**NRC Public Meeting on the Review of Emergency Preparedness
Regulations and Guidance for Commercial Nuclear Power Plants
(8/31 - 9/1/05)**

Comments Mary Lampert, Town of Duxbury, Massachusetts

EMERGENCY PLANNING IN THE EVENT OF A NUCLEAR DISASTER

Appendix 2

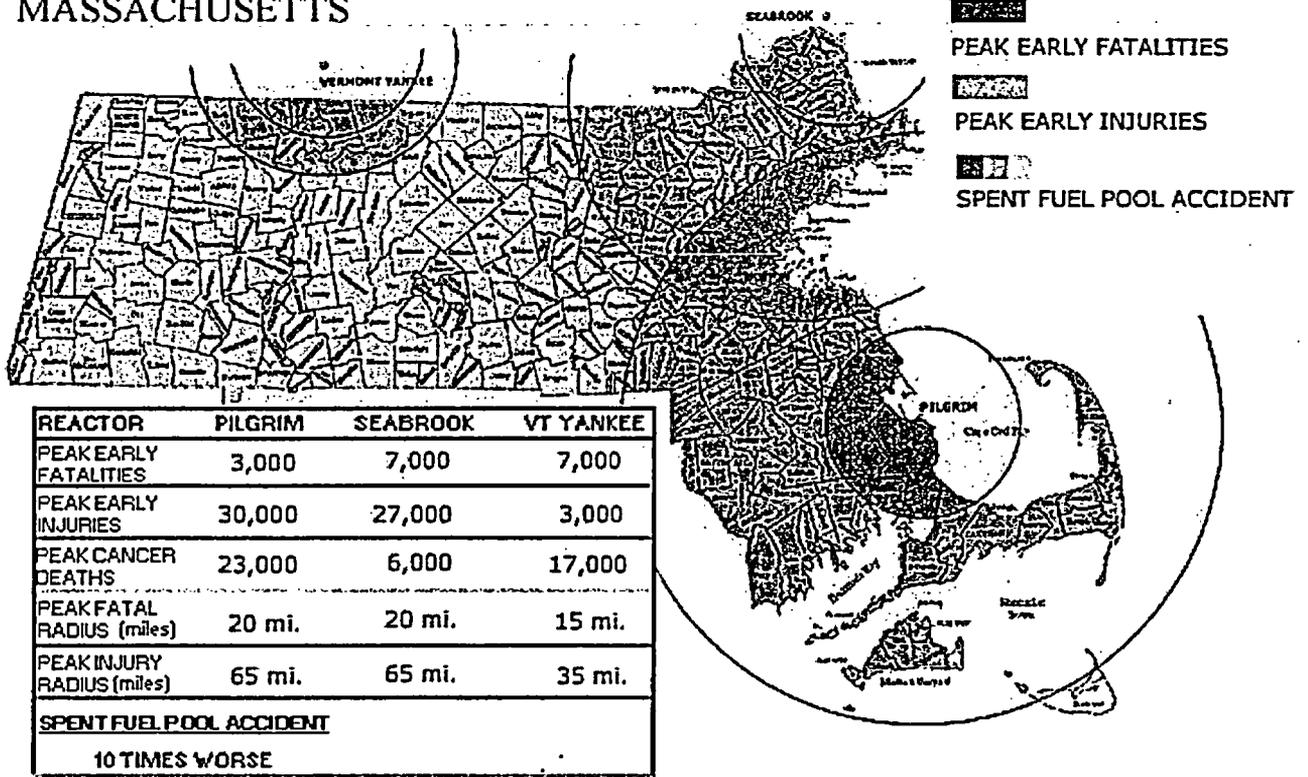
However a core melt at Pilgrim NPS, calculated by the federal government, would result in a 20 miles peak 1st year fatal radius; a 65 miles peak 1st year injury radius; and 23,000 peak cancer deaths.² A spent fuel accident would be many times worse. See Appendix 2 for a graphic.

Peak Early Fatalities are deaths that result within the first year. The **red area** represents the zone for peak fatalities. This radius is the largest calculated distance from the plant at which early fatalities are expected to occur for a core melt.

Peak Early Injuries are radiation-induced injuries occurring in the first year that require hospitalization of other medical attention – such as sterility, thyroid nodules, vomiting and cataracts. The **orange area** represents the zone for peak early injuries. This radius is the largest calculated distance from the plant at which early injuries are expected to occur for a core melt.

Spent Fuel Accident - In the case of a spent fuel pool accident, **red, orange and yellow** areas would experience more than 10 times the radioactivity released in Chernobyl, and the consequences, 10 times worse!

APPENDIX 3: Wind Movement around Pilgrim

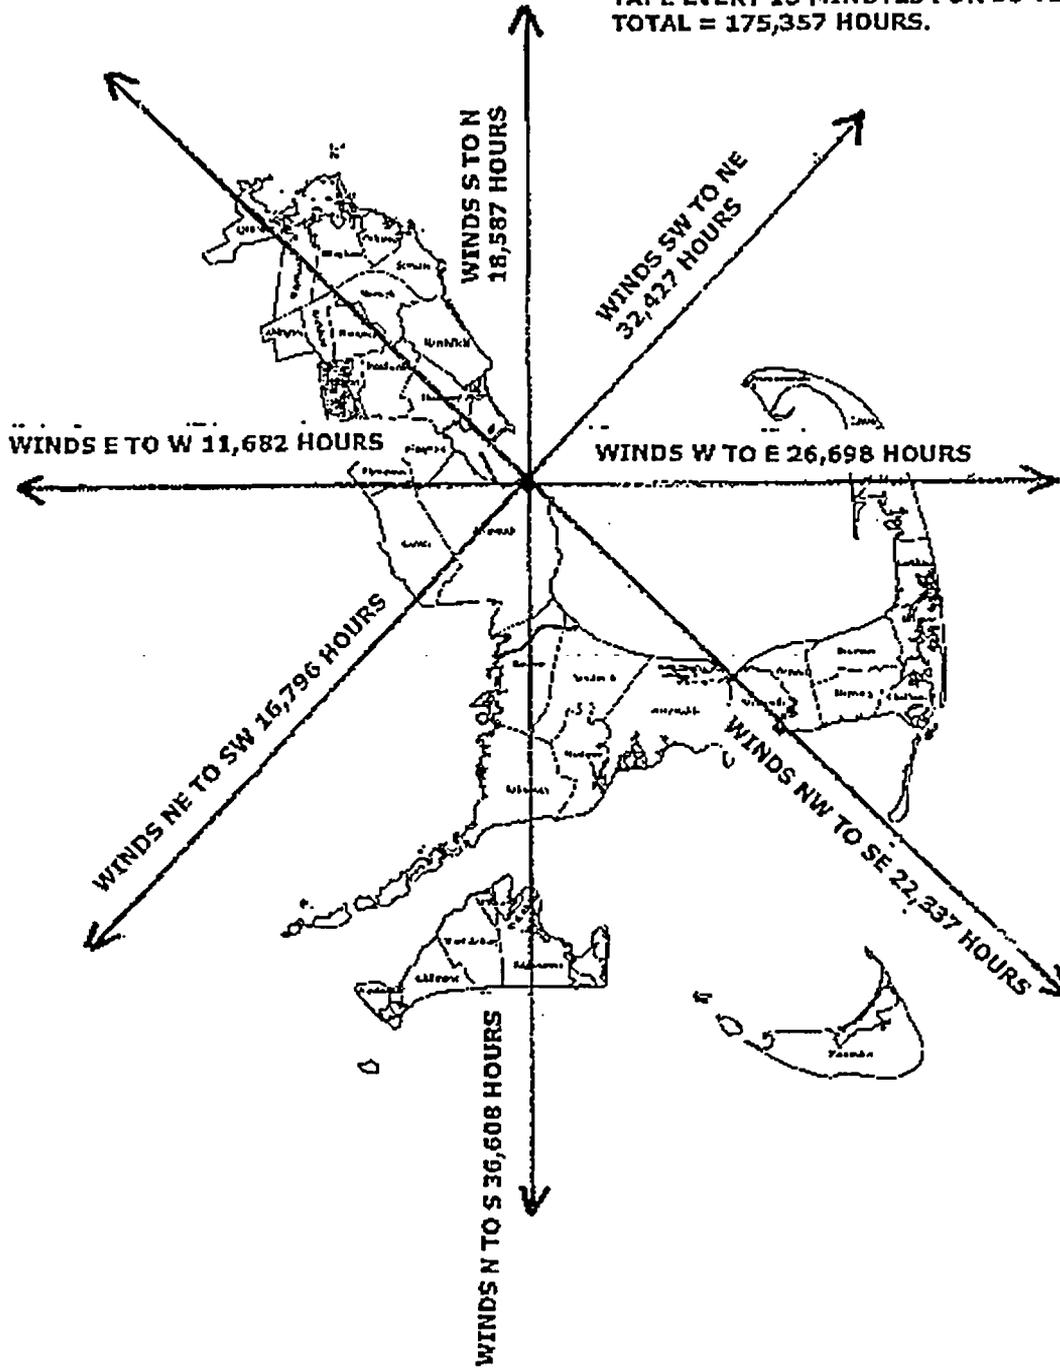
Analysis: Pilgrim is located on the coast and the wind is highly variable. Therefore planning must be for the entire radius – not simply for those inside one imaginary "relatively narrow plume."

The "key hole" is contradicted by actual weather analysis; however, it allows for limited resources to appear adequate.

Recommendation Planning and targeting resources on the "key hole" should be taken out of all plans and procedures. Communities should refuse to move their resources to service another community in a nuclear disaster and not count on resources from other near-by communities to provide service to them in a nuclear disaster. Help should be contracted with communities not expected, realistically, to be affected by the disaster and more important that their own population will not react to the news necessitating a strain on their services.
